# Richmond High School: Mechanical Modernization Project LWC Commission No. 20104.02

# ADDENDUM #01 September 16, 2021

MECHANICAL CONTROLS

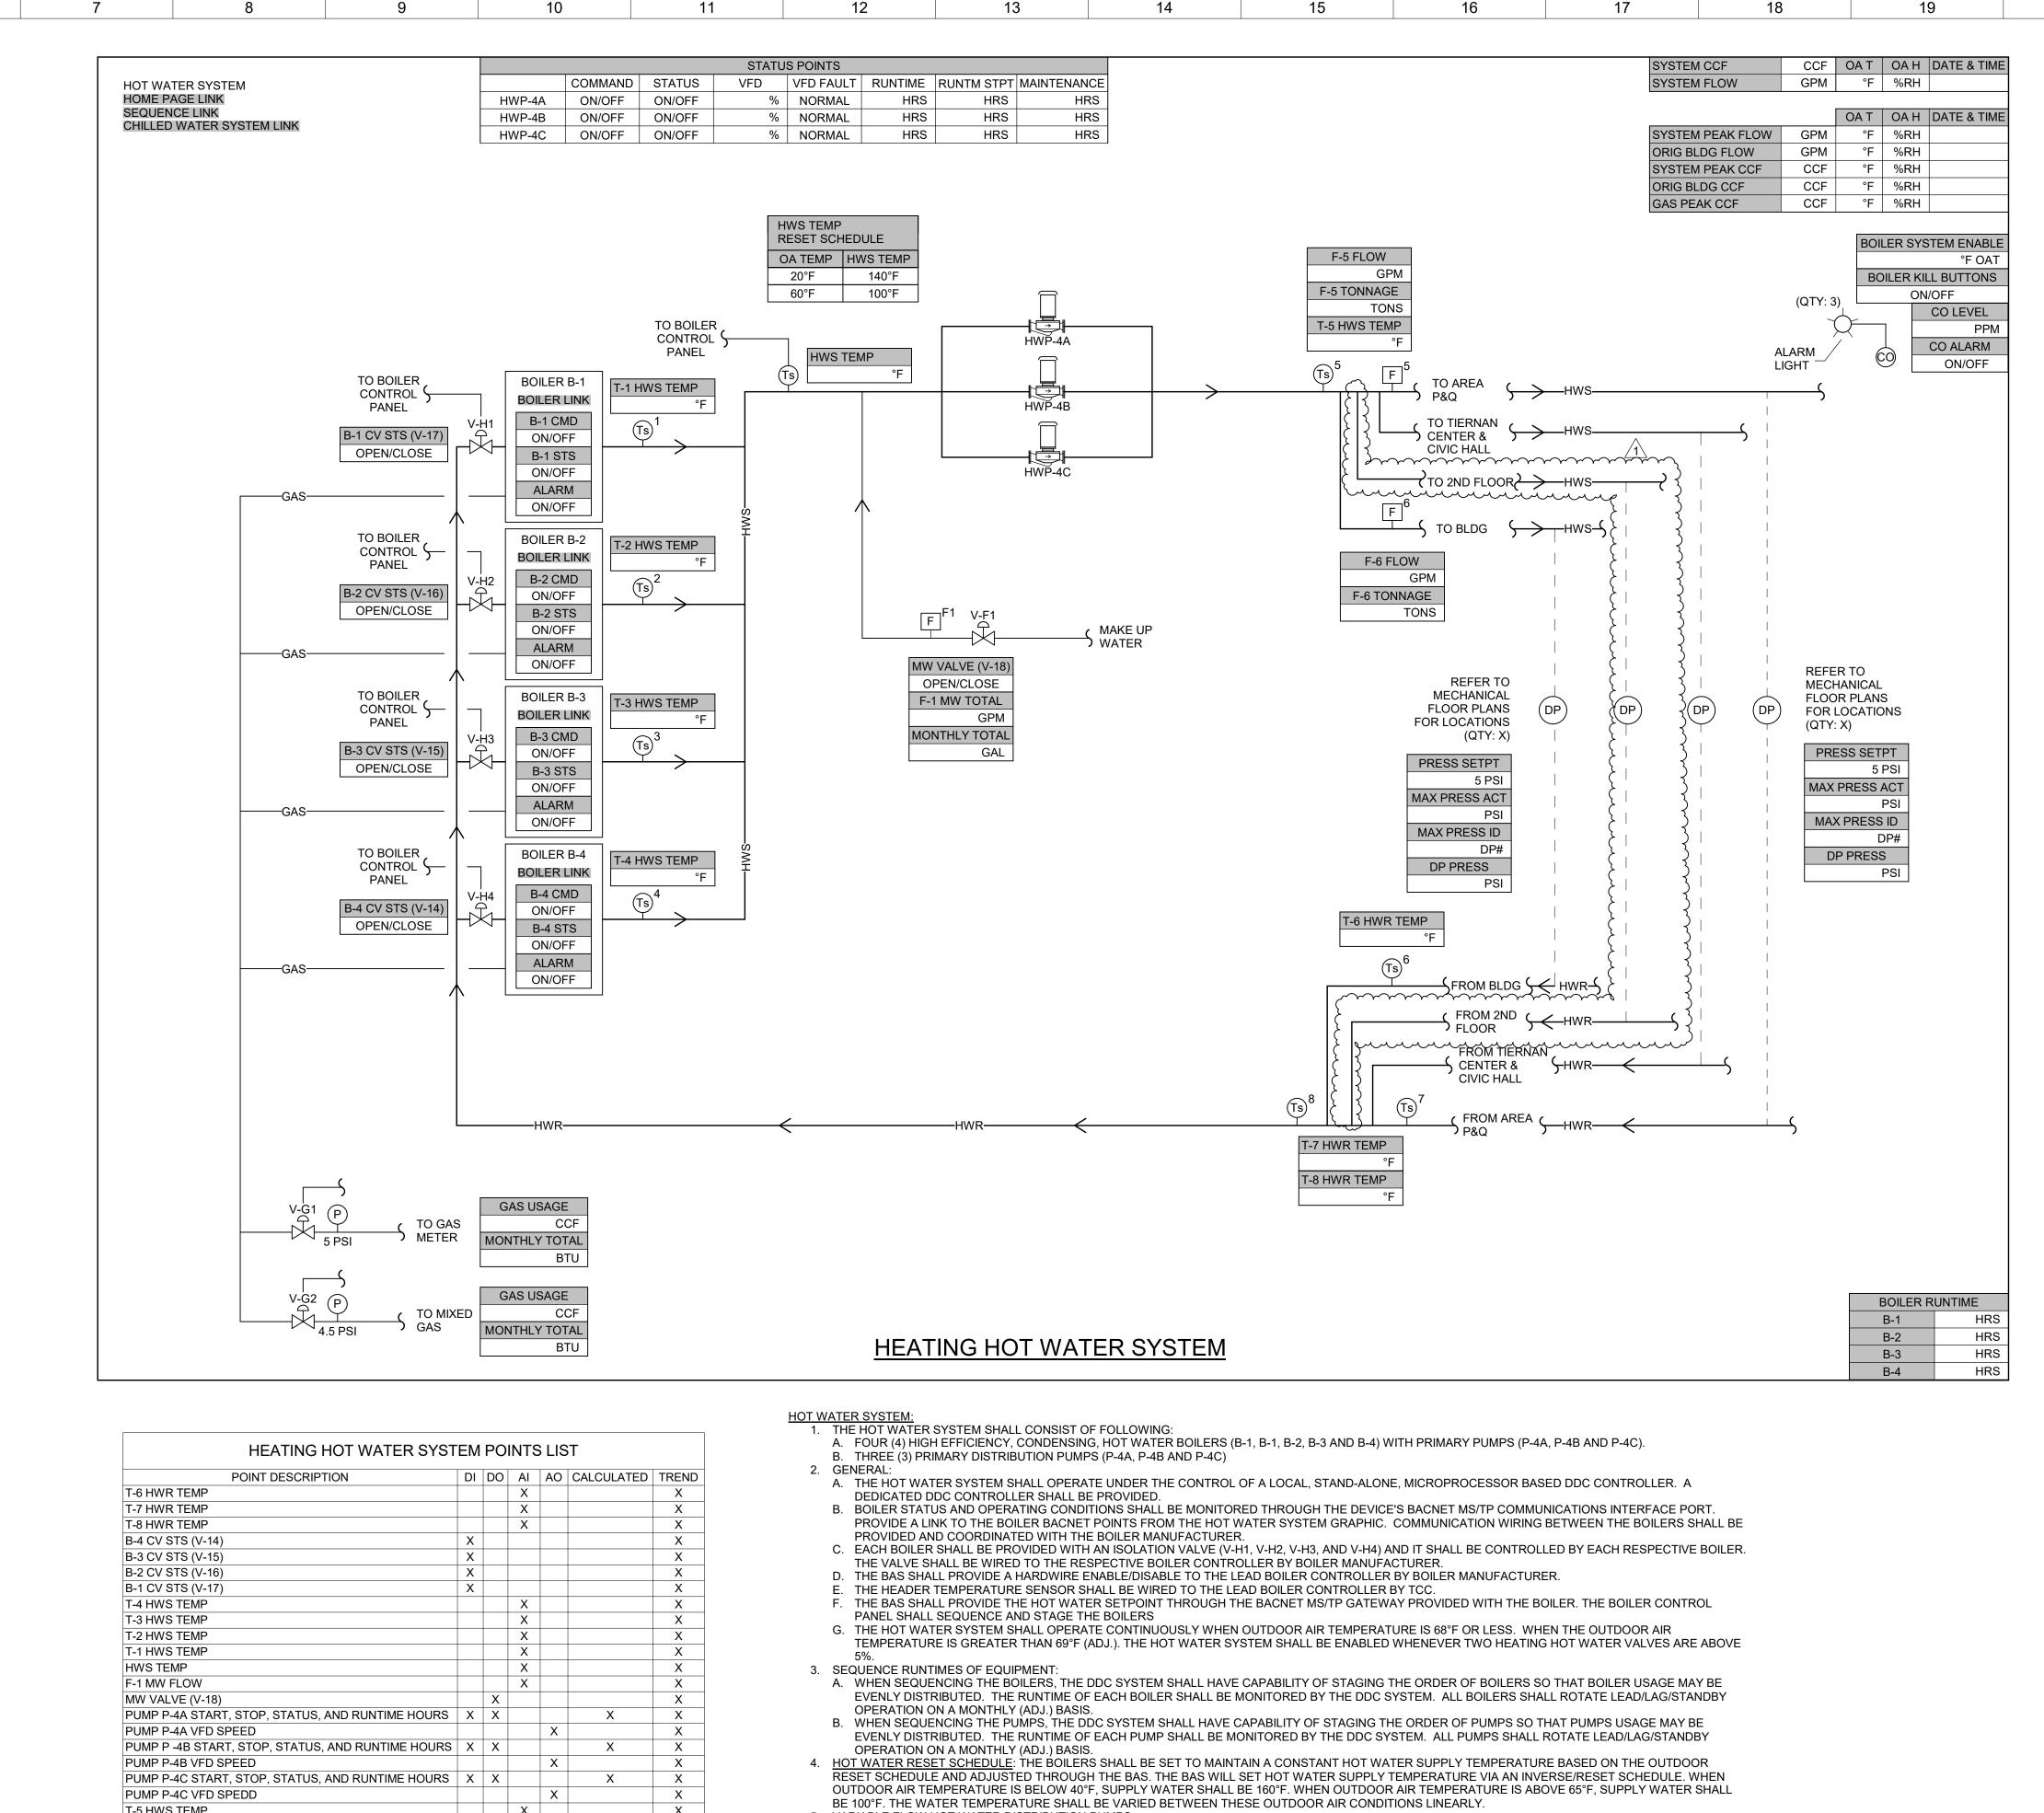
A. Additional Differential Pressure sensor added for 2<sup>nd</sup> floor on hot water loop.
